Location:  
41 E. Main Street

Request:  
Major Site Plan

Staff Recommendation  
Approval subject to  
conditions on page 9.

Hudson Planning Commission	SITE PLAN REVIEW – VILLAGE DENTAL
Case No. 25-1022	October 13, 2025

Fig 2

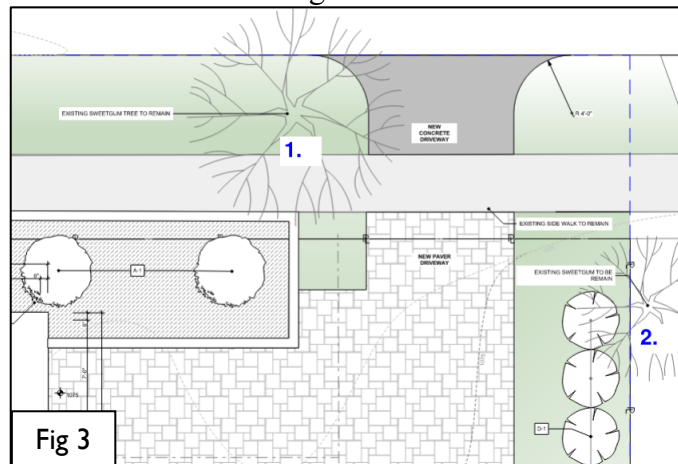
Staff Comment: Staff notes the proposal would relocate an existing curb and provide additional separation from E Main Street; however, it will result in 3 consecutive curb cuts along Division Street (See Figure 2).

While there is no specific code issue on this item, question if the applicant has explored the feasibility of a shared access easement with the adjacent driveway to the east. This would eliminate the concern for multiple driveway aprons and ensure the mature street tree is protected as further described on page 6.

1. Design of the addition will require final approval by the Architectural and Historic Board of Review.
2. Provide documentation that it is infeasible to eliminate the proposed driveway curb cut.

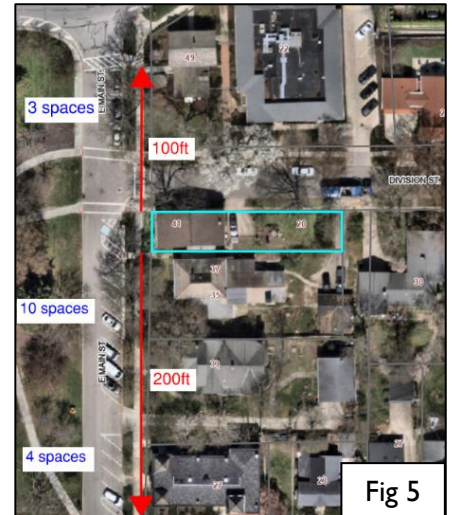
1. If the proposed improvements are made to the site, the existing mature red oak located within the city right of way (identified as a Sweetgum Tree on the plans) would be compromised (Location marked as #1 in Figure 3 below). The tree measures 33" DBH and 36" diameter-at-base and is estimated to be 65 feet tall. The structural root zone (SRZ) is calculated to be 9' radius. No buttress roots within this SRZ shall be severed as it put the tree at risk of failure. Additionally, the tree protection zone (TPZ) would be, at minimum, 49-foot radius. Any cuts, fills, compaction, or otherwise damage to roots within this TPZ could compromise the tree's health and cause decline.

2. Additionally, there is a Sweetgum located on the adjacent parcel that could be affected by the proposed development (Location marked as #2 in Figure 3 below). The proposed area of disturbance falls within the TPZ but not the SRZ. Any damage to roots within the TPZ would potentially lead to a decline in health for the sweetgum.

Staff notes the proposed concrete drive apron is proposed directly adjacent to the mature street tree. Staff has previously recommended the applicant explore the feasibility of entering into a shared access agreement to utilize the neighboring drive to the east. Such would reduce the total number of adjacent curb cuts and potentially protect the mature street tree. Question if the applicant has explored this possibility. Additionally, the applicant should provide additional documentation/protection measures for the adjacent Sweetgum tree.

3. Provide additional documentation regarding protection measures for the existing Sweetgum tree identified in Figure 3 of this report.
4. Revise the landscaping drawings to incorporate evergreens along the eastern property line.
